Pedestrian Kinematics Assumptions

JAPAN AUTOMOBILE STANDARDS INTERNATIONALIZATION CENTER

Comments on pedestrian kinematics assumptions in the discussion of the detection area

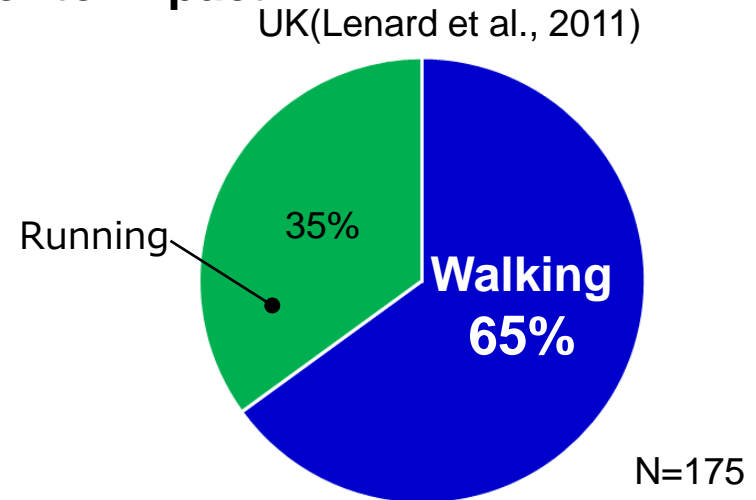
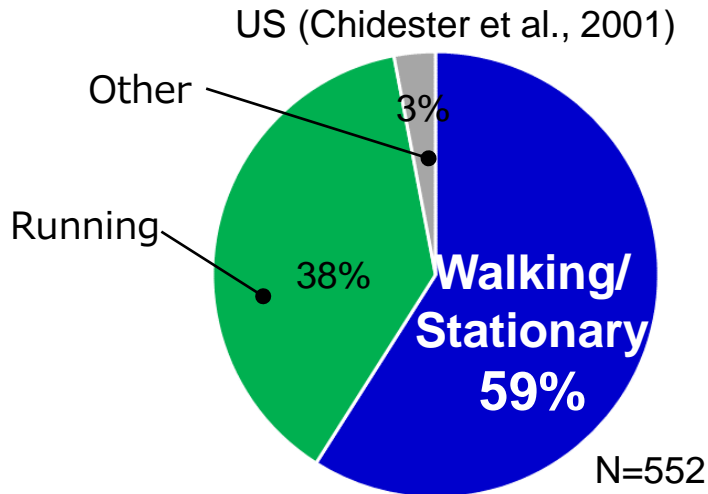
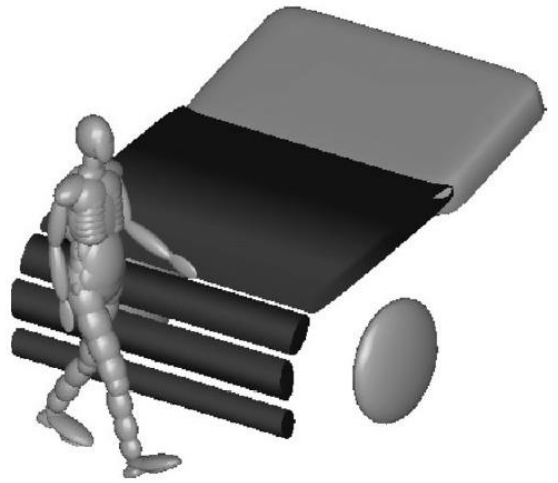
A walking pedestrian hit laterally by a vehicle is representative(majority) accident scenario in real world

- At the last IWG meeting, Germany presented example cases showing that impact point of the head in lateral direction of the vehicle wasn't same as that of the leg.
- However, according to the analysis results of in-depth pedestrian accident data, a stationary pedestrian laterally hit by a vehicle assumed in the current GTR9 can be regarded as representative accident scenario, meaning that assumed kinematics in the current GTR9 represents real world accident.
- Japan thinks that the assumed kinematics in the GTR9 should be same.
- Therefore, Japan proposes that the pedestrian kinematics assumption in the discussion of the detection area should be same as that in the current GTR9.
- If IWG doesn't use representative(majority) scenario to DPPS, IWG needs to reconsider assumed accident scenario in the current GTR9.

Simulation setup

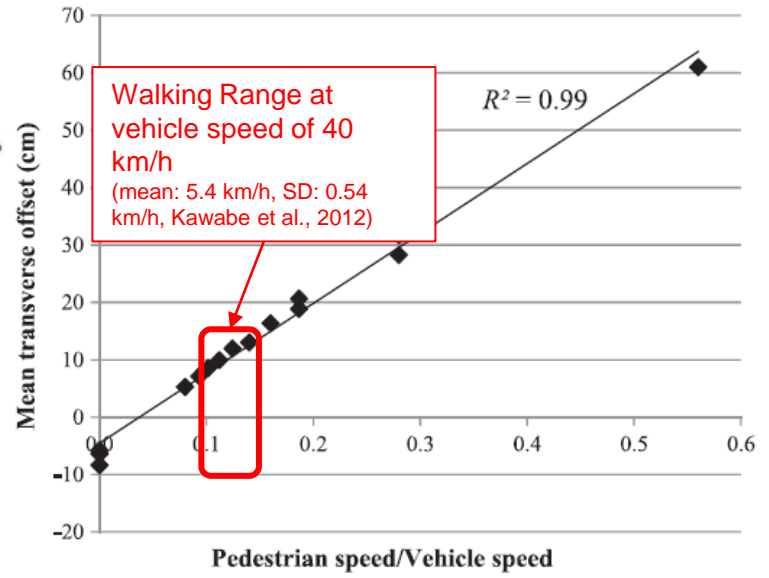
- Lateral offset of the head impact point relative to the leg impact point is approximately 100mm at average walking speed
- This lateral offset is similar to the test and simulation result presented from JASIC (IWG-DPPS-10-04)

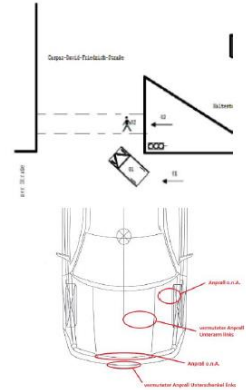
Low speed and not lateral collision

Accident cases with large lateral offset between leg and head impact point does not seem representative accident scenario
